## **CABINET MEMBER FOR ENVIRONMENT – 3 SEPTEMBER 2015**

### **PROPOSED SPEED LIMIT CHANGES, TURNING BAN & TRAFFIC CALMING – HAGBOURNE HILL AND CHILTON ROAD, SVUK AREA**

**Report by Deputy Director for Environment & Economy (Commercial)**

HAGBOURNE HILL AREA:  
PROPOSED 40MPH SPEED LIMIT

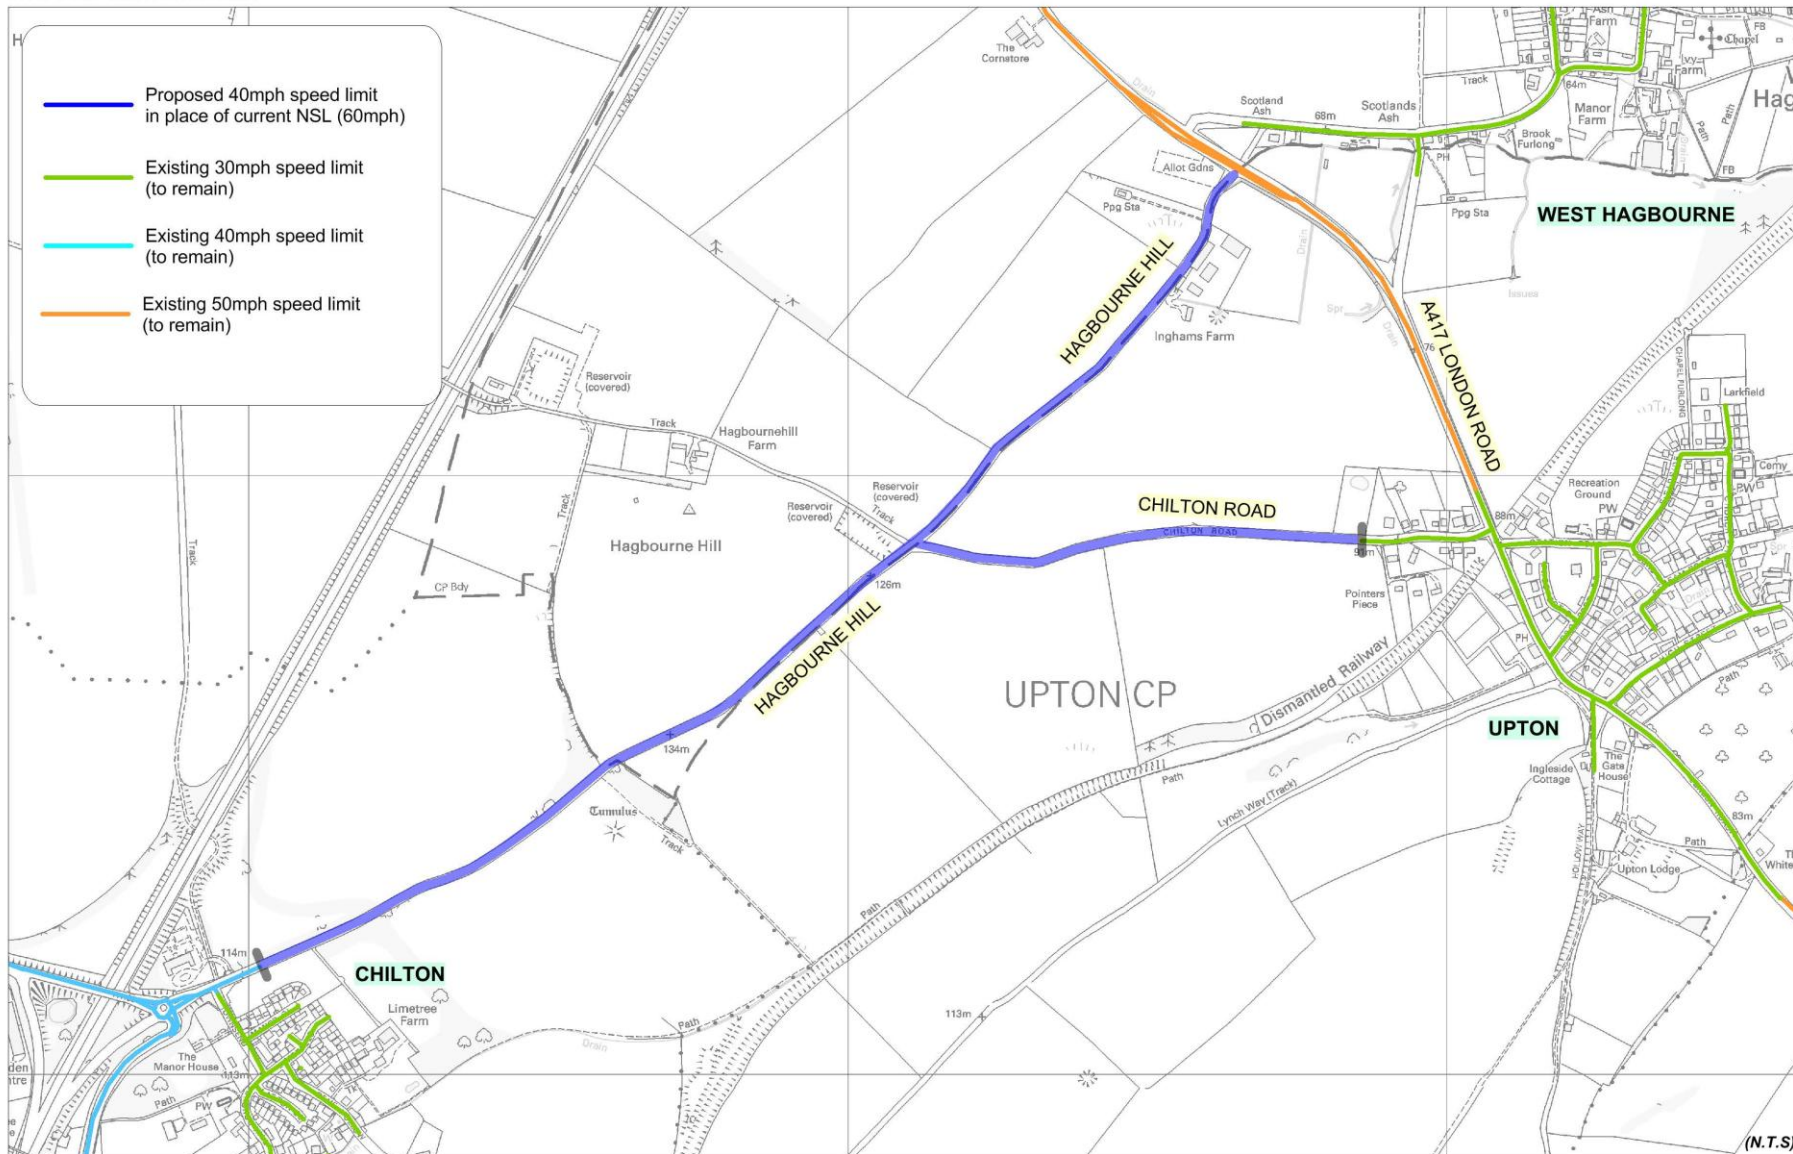
10. Thames Valley Police objected to the proposal on the basis that the 85<sup>th</sup> percentile speed survey data provided demonstrates that the existing 60 mph National Speed Limit is appropriate for the road environment. The Police view the existing 85<sup>th</sup> percentile speed of traffic as an indicator of how acceptable the introduction of a new speed limit will be. If the 85<sup>th</sup> percentile speed of existing traffic is 7 mph or more over the proposed new limit, they consider the new proposal as unlikely to be effective without other measures such as engineering or continual enforcement.

11. The speed survey locations are shown at Annex 2. 85<sup>th</sup> percentile speeds of approximately 57-58 mph were recorded at survey locations A and B, to the east of the Chilton Road intersection. This moderated to 54 mph at survey location C, closer to A417. These results are out of tolerance with the police acceptability criterion as stated above, being a large margin in excess of the stated threshold of 7 mph above the proposed new limit.

12. Upton Parish Council has no objection to the lowering of the limits.
13. Public response was mixed, with three objections and also some concerns being raised about driver compliance with the proposed limit and the police's ability to enforce. One objection was on the basis that the measure is not necessary, with vehicles currently able to travel in safety at 60 mph over the majority of the length of the road. Another objector points out the road was improved recently and that traffic is able to exceed 40 mph in complete safety. Where speed limits are artificially low, unreasonably constraining the progress

of cautious drivers, they serve only to increase frustration, contention and pollution. The final objector views the proposal as pointless, and advises that there may be a small merit in a 50 mph limit.

17. The County Council applies the Department of Transport guidelines on setting local speed limits as the basis for determining the appropriate limit for any specific location. It is acknowledged that the character of this road lies somewhat outside the usual parameters for a 40mph limit as given in the DfT guidelines, but the latter do provide for some flexibility, and in this instance, taking account of the concerns of the local community over the increases in traffic volumes and speeds using local networks as a result of the Science Vale wider proposals, the proposed 40 mph speed limit is judged to be broadly consistent local opinion and the wider strategy for the Science Vale area.

HAGBOURNE HILL AREA - CHILTON ROAD:  
PROPOSED 40MPH SPEED LIMIT

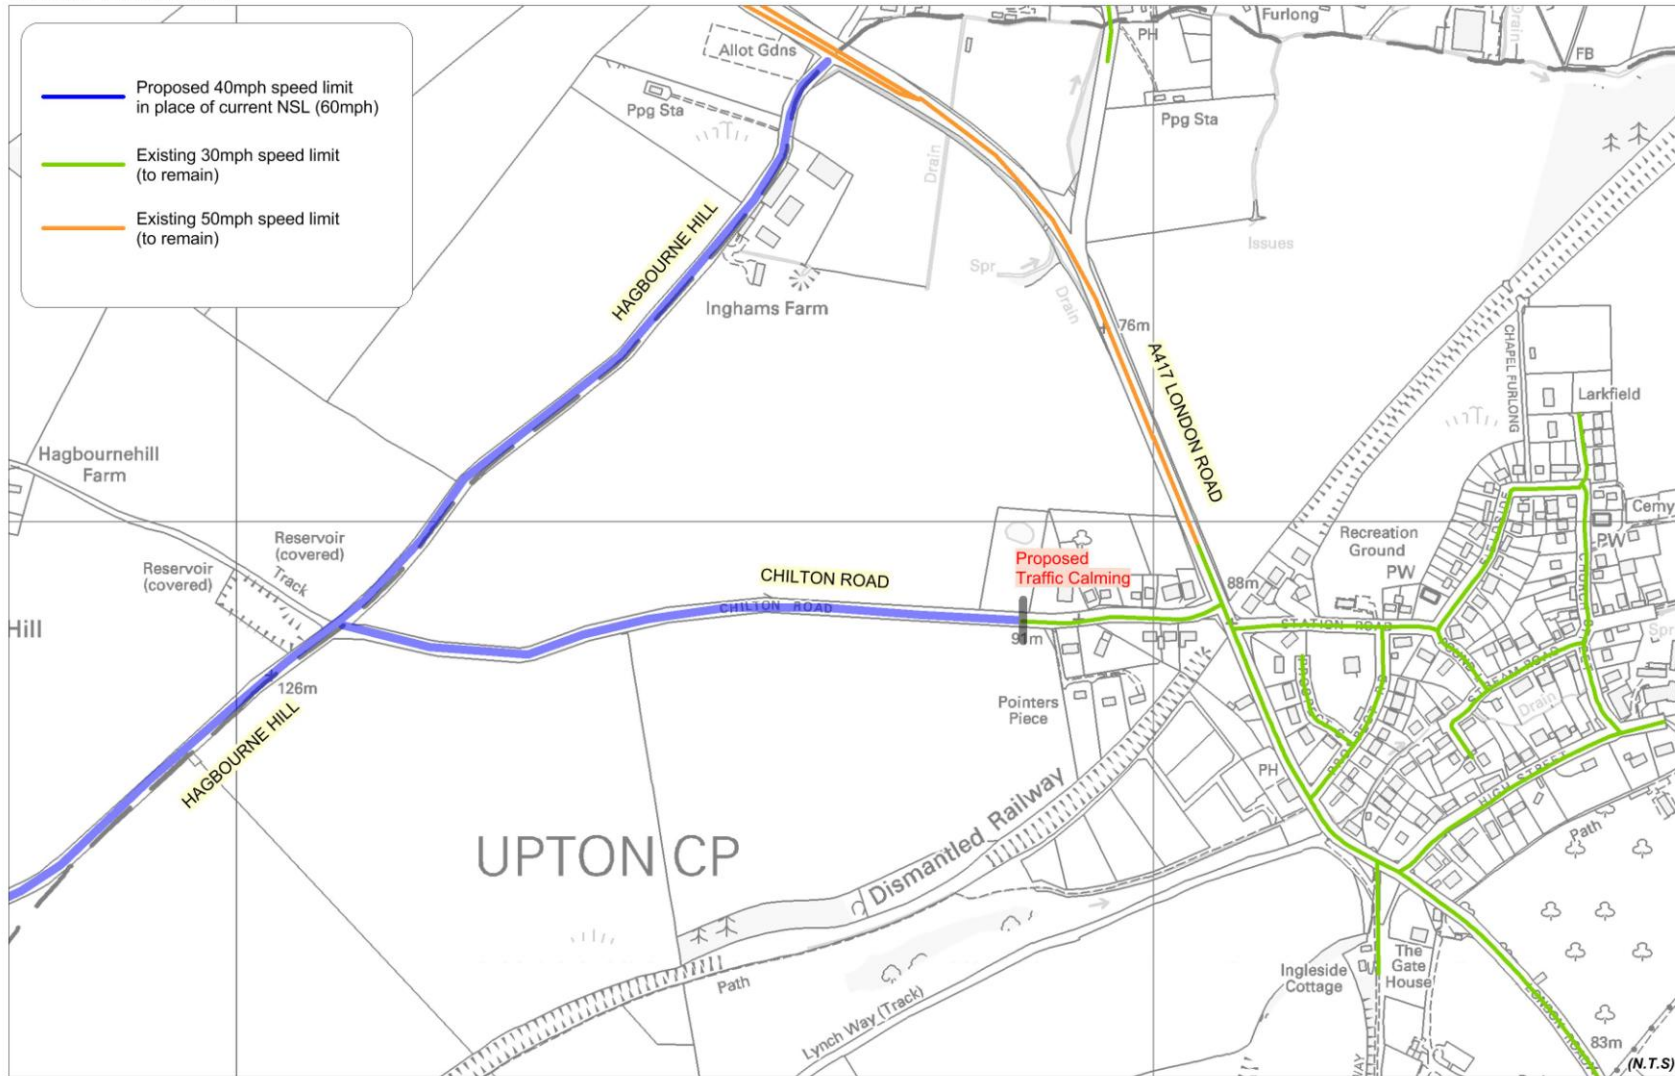
14. Thames Valley Police objected on the basis that the speed survey data provided by OCC show that the existing National Speed Limit is appropriate for the road environment. They will not support lowering this speed limit to 40mph. Speed survey data shows an 85<sup>th</sup> percentile speed of around 49 mph at the single survey location D on Chilton Road.
15. Upton Parish Council had no objection to the lowering of the limits but requested a change in position of the start of the existing 30 mph limit to move it much further to the west, to achieve reliable speed reducing effect.
16. Public response is more supportive for the restriction on Chilton Road than Hagbourne Hill. Concerns and comments raised include whether the proposed limit will be adhered to, that existing speeds do not appear excessive, and that the past safety record of the road is good.

18. The request from Upton Parish Council that the start of the proposed 40 mph limit (and coincident start of 30mph zone) should be moved further to the west than that advertised, by around 25 - 30 metres, which will coincide with the revised position of the build out (see below) is accepted.

Drawing No. S-5129022-FA-000-075		Revision 1

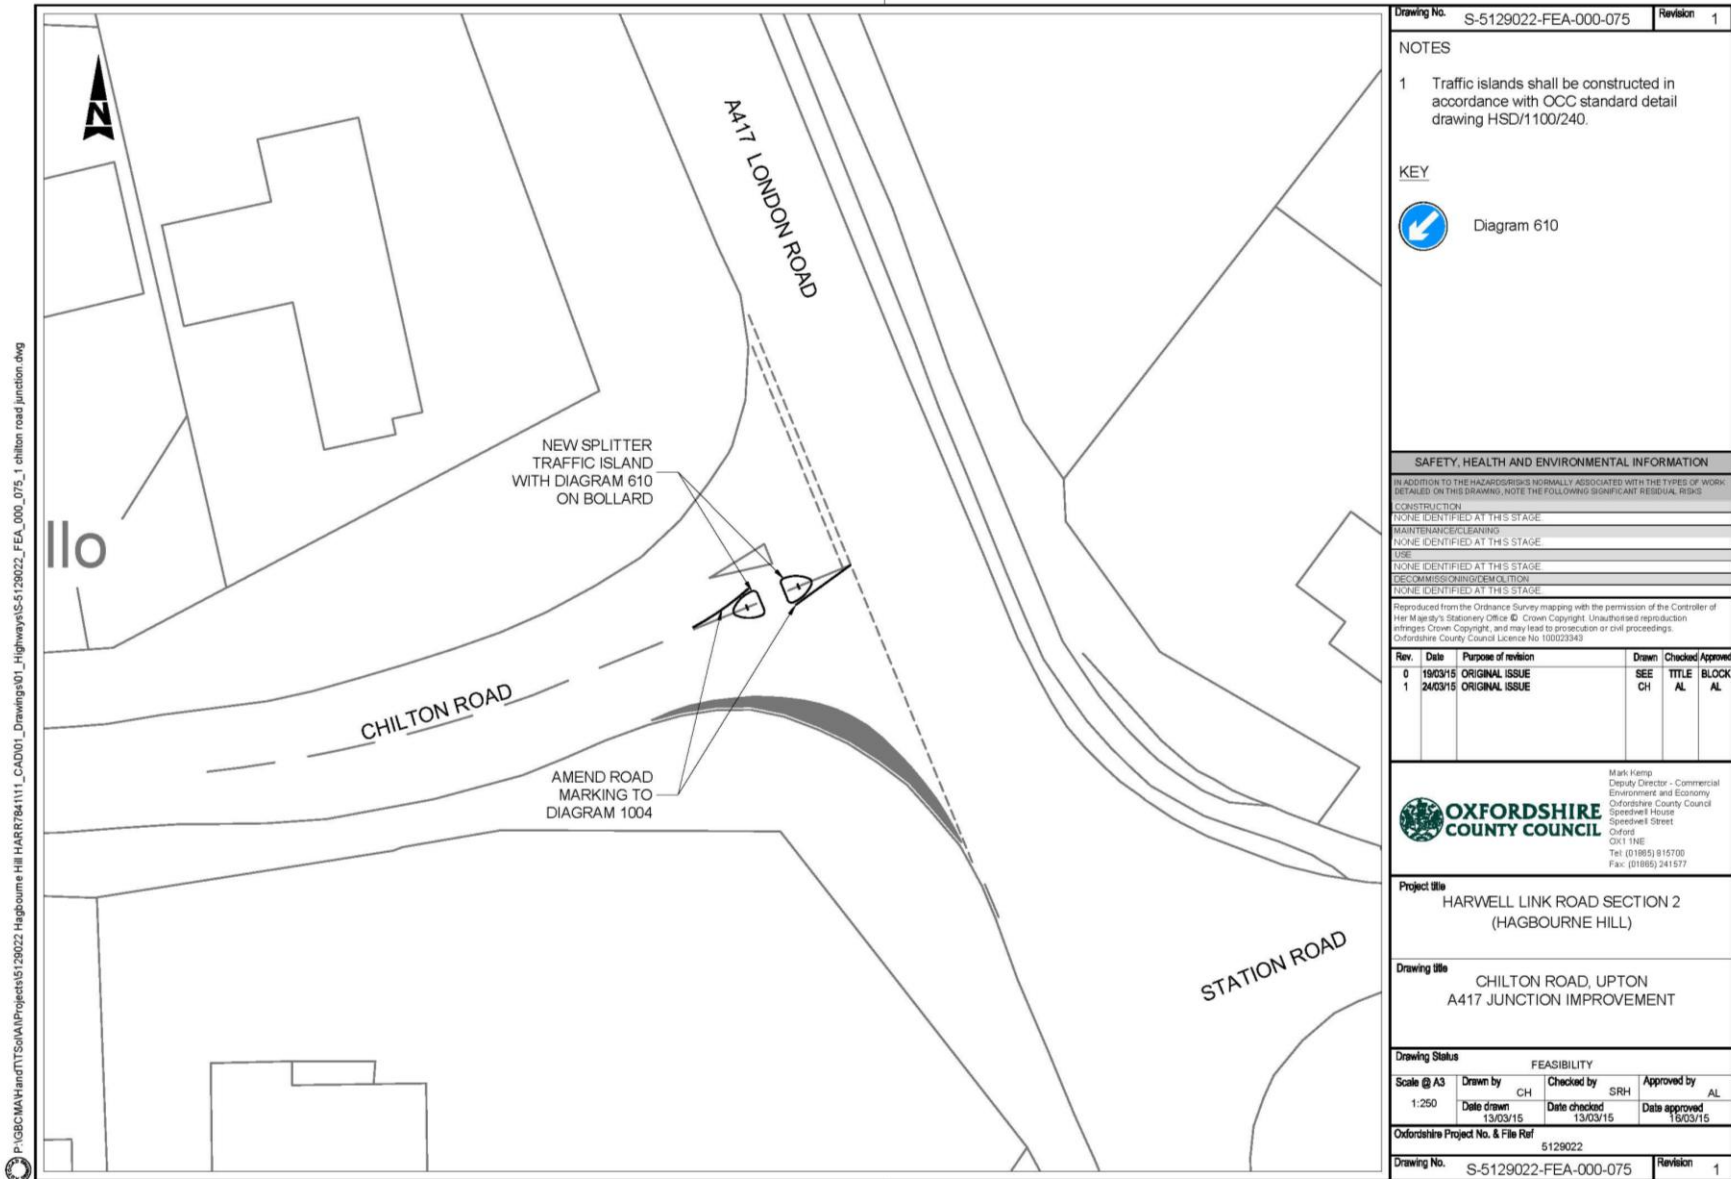
26. Upton Parish Council responded that they neither objected to nor supported the proposal and commented on how it could be improved. They consider that proposal will not have the desired effect to slow down left turning traffic which comes from the Blewbury direction, and suggest narrowing the junction, which will force vehicles to slow down. The majority of public respondents supported narrowing of the junction, reflecting the Parish's views

27. In order to meet local aspirations, a compromise is suggested with the entry radii tightened with an over-run area provided to accommodate the larger HGV vehicles.
